On TDECQ and Overshoot Specifications

(in support of comments 7, 12, 50, 66, 67, 10 and 49)

IEEE P802.3db 100 Gb/s, 200 Gb/s, and 400 Gb/s Short Reach Fiber Task Force

P802.3db TF Interim Teleconference

Considerations for TDECQ (max)

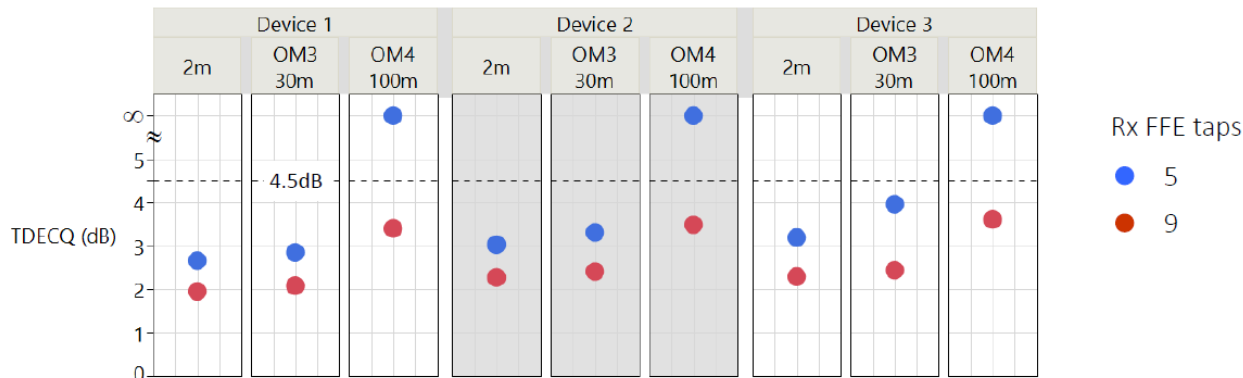
- SR Links: Manufacturing requires margin
[ingham 3db adhoc 01a 062520.pdf](#) presentation shows TDECQ between 3 and 4 dB on 100m OM4 links.
- VR Links: Low cost
 Enable slower VCSELs \Rightarrow allow for higher TDECQ.
- Different values of TDECQ(max) for SR and VR will require an additional transceiver test on SR links to ensure interoperability.
- TDECQ(max) for SR and VR differing by 0.2 dB does not have a big impact on the worst optical waveform presented to the receiver.

Different TDECQ(max) for SR and VR requires an additional test on SR transceivers.

Proposal for TDECQ (max)

Overshoot

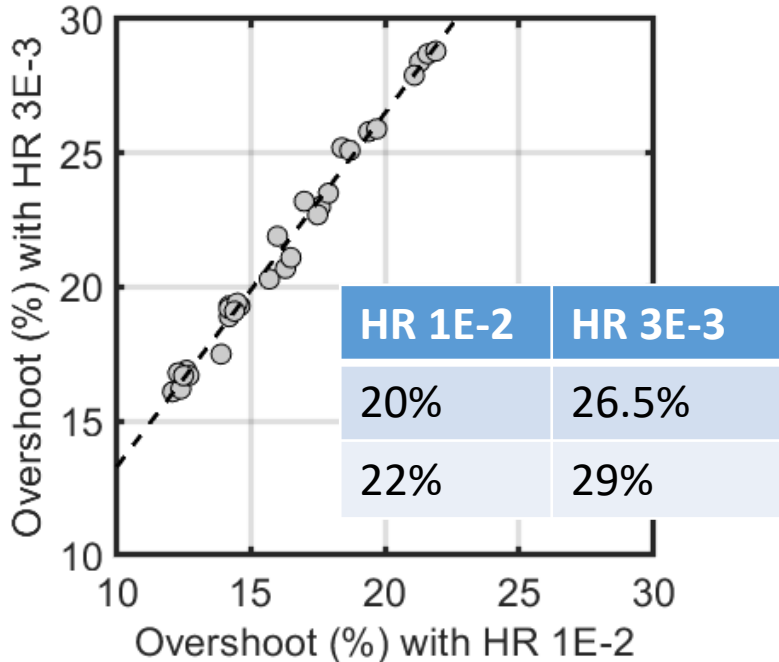
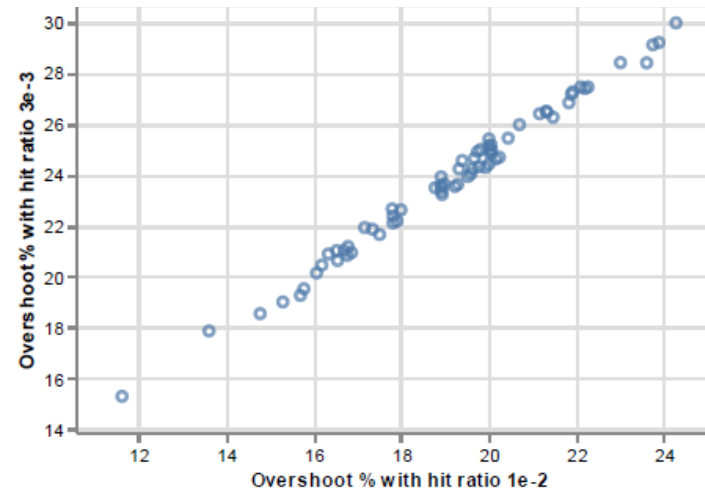
- Overshoot/undershoot (max) was a TBD in the baseline proposal, [murty 3db adhoc 01b 121720.pdf](#), to identify any differences between a VCSEL-based link and SMF links. [ghiasi 3db 01 092321.pdf](#) is the first presentation on the topic in this Task Force.
- Considerations that apply to SMF links also apply to MMF links.
- There is good correlation between overshoot/undershoot (max) values with hit ratios 1E-2 and 3E-3.

The captured data shows a tight correlation between hit ratios. A direct translation from one hit ratio to another can be done. For instance, 22% overshoot measured with 1e-2 hit ratio is equivalent to:

□ 27% at 3.3e-3

[rodes_3cu_01a_052620.pdf](#) used a 10 – 20X degradation in BER as a guide in setting the overshoot/undershoot (max).

Using similar considerations, propose setting the overshoot/undershoot(max) the same as for SMF links, but specified at 3E-3 hit ratio.
